# Central Falls High School

## 100% Construction Documents

Ai3 Project #2202.02

### **Addendum #3**

2 INTERIOR WALL SECTION  
3/4" = 1'-0"

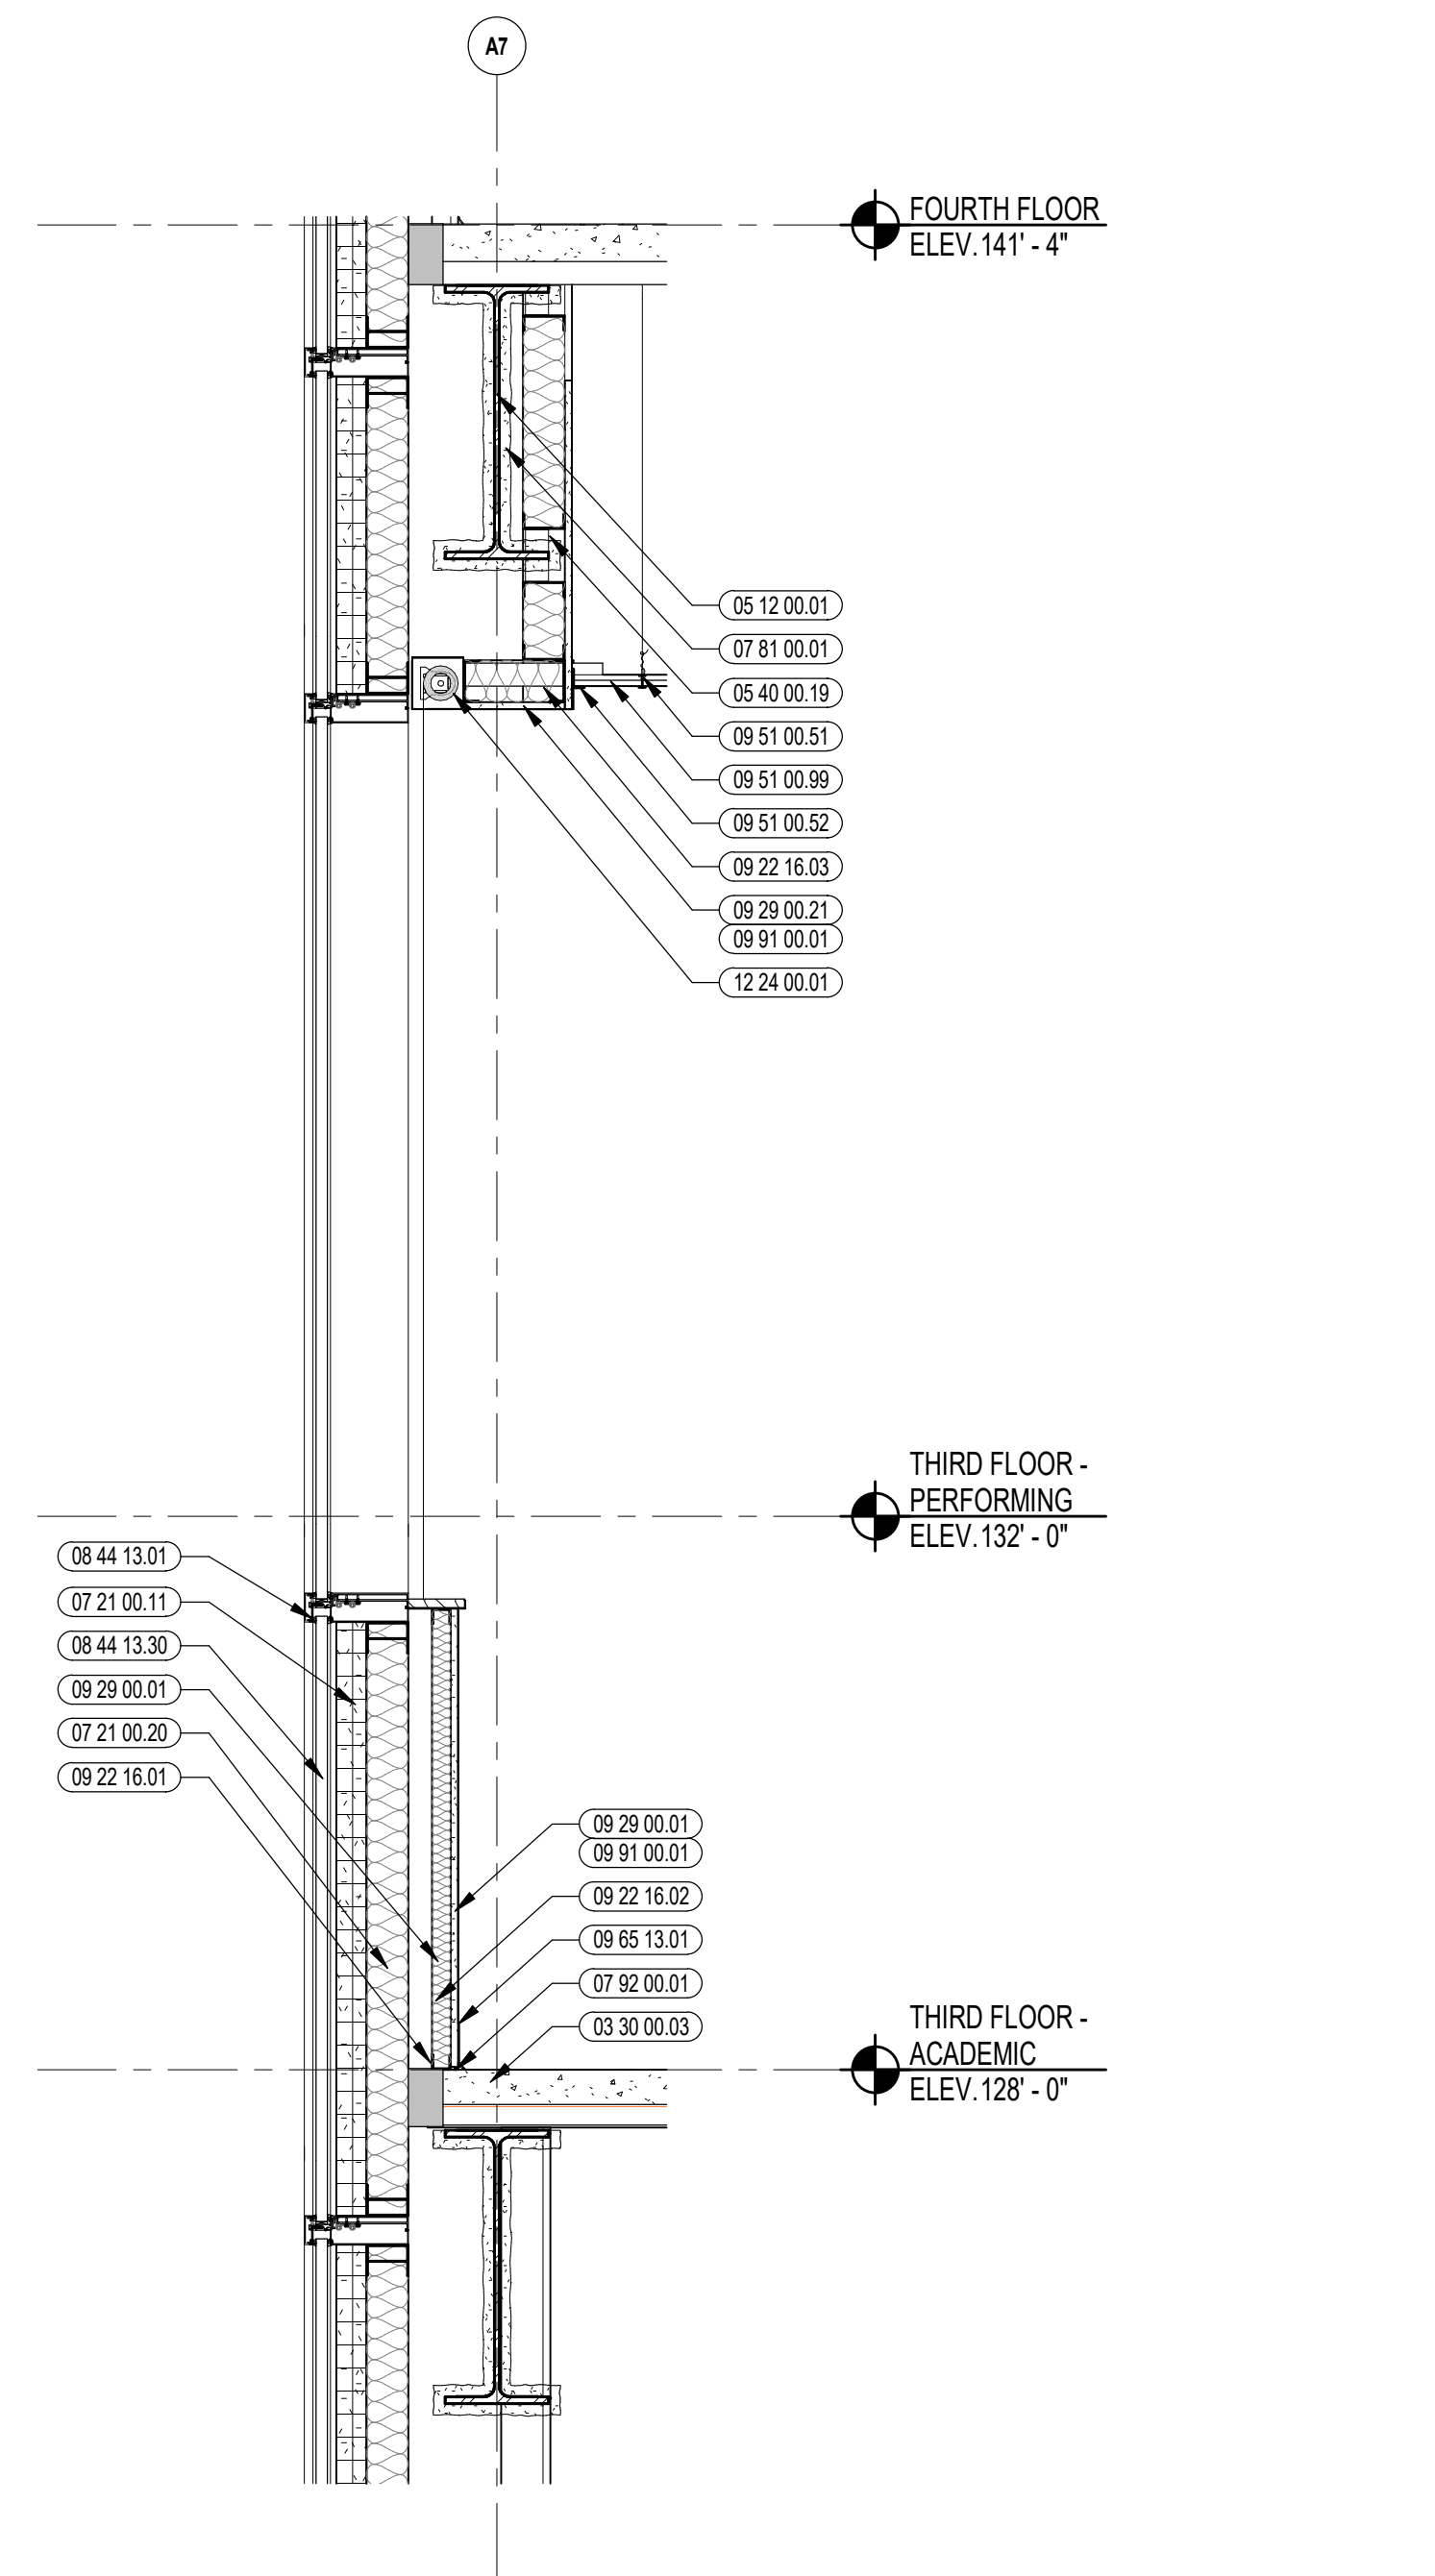
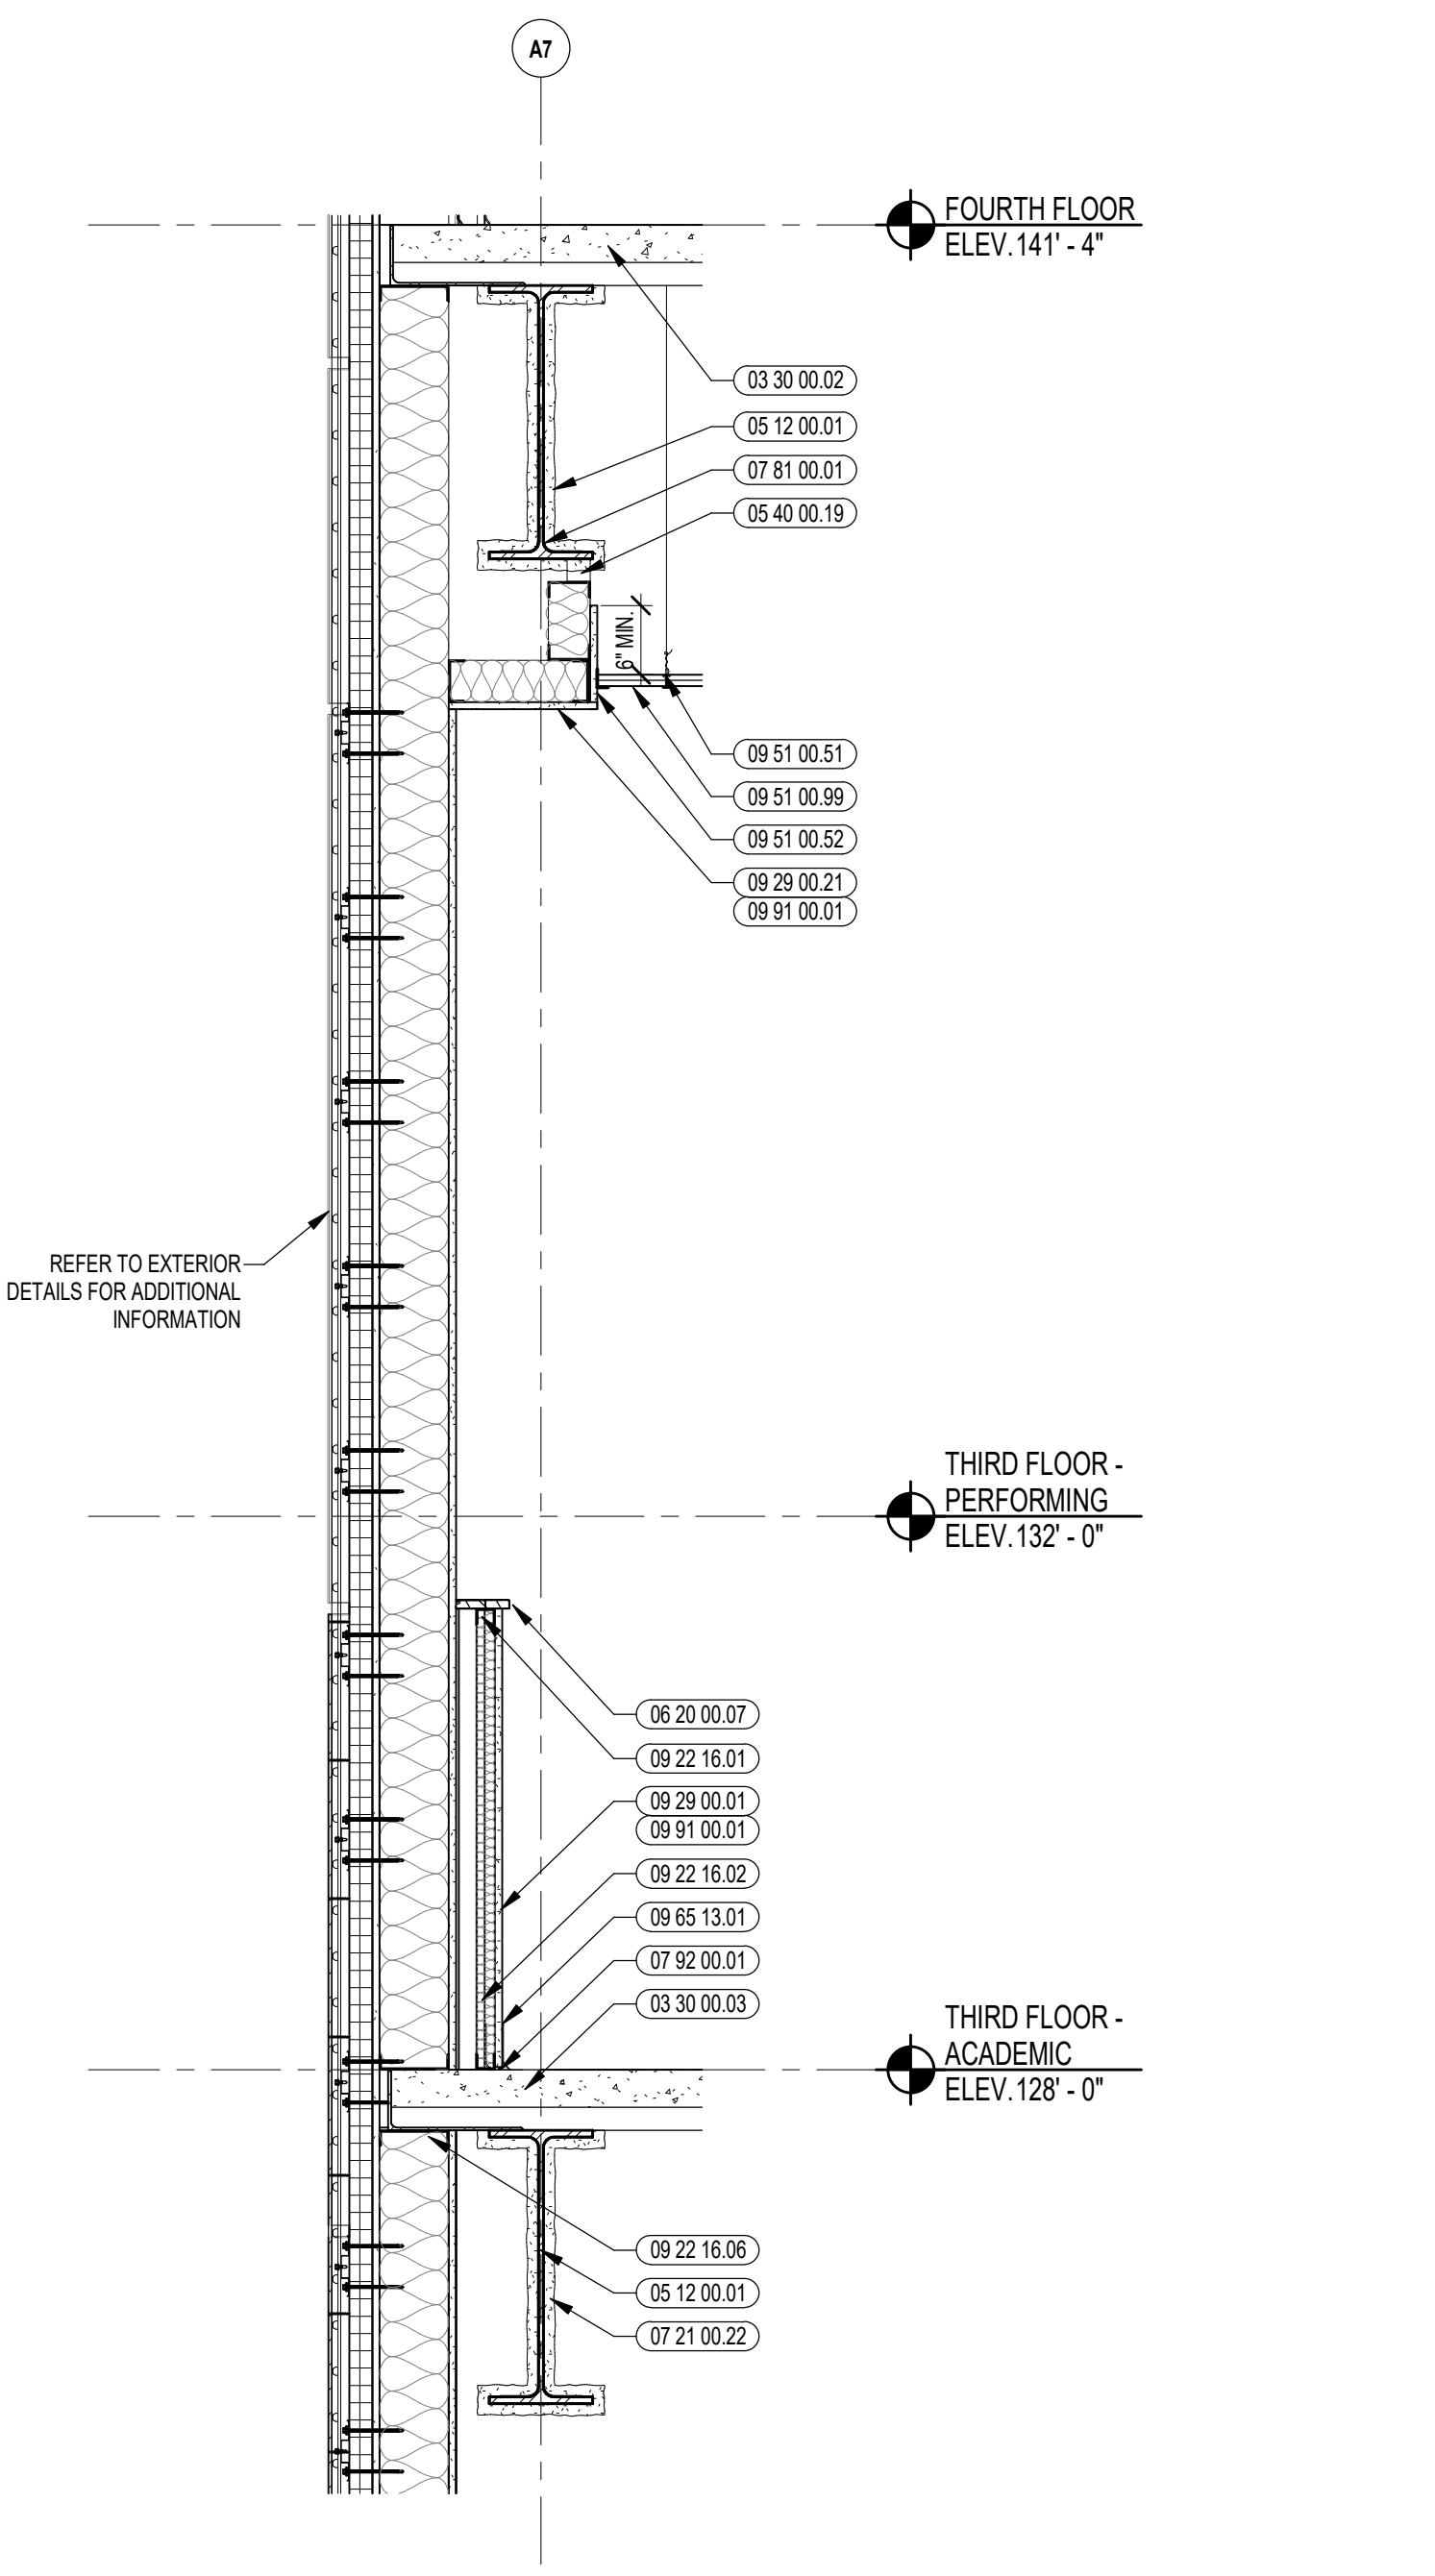
**ADD 3-002** **Bidder Question:** There doesn't seem to be drawings with Window Shade (Section 12 24 00) locations or any notes of the shades on the finished plans. The specs under part 2.1, they state there are roller shades manual, dual roller shades manual, blackout shades manual, and blackout shades motorized with locations for the blackout shades manual and blackout shade motorized. Where are these located? **Response:** Refer to opening details, interior wall sections, enlarged floor plans and elevations for keynoted shade

locations. See additional clarifications on A7.73, A9.25A, A10.20C and A10.41 in Addendum #3.
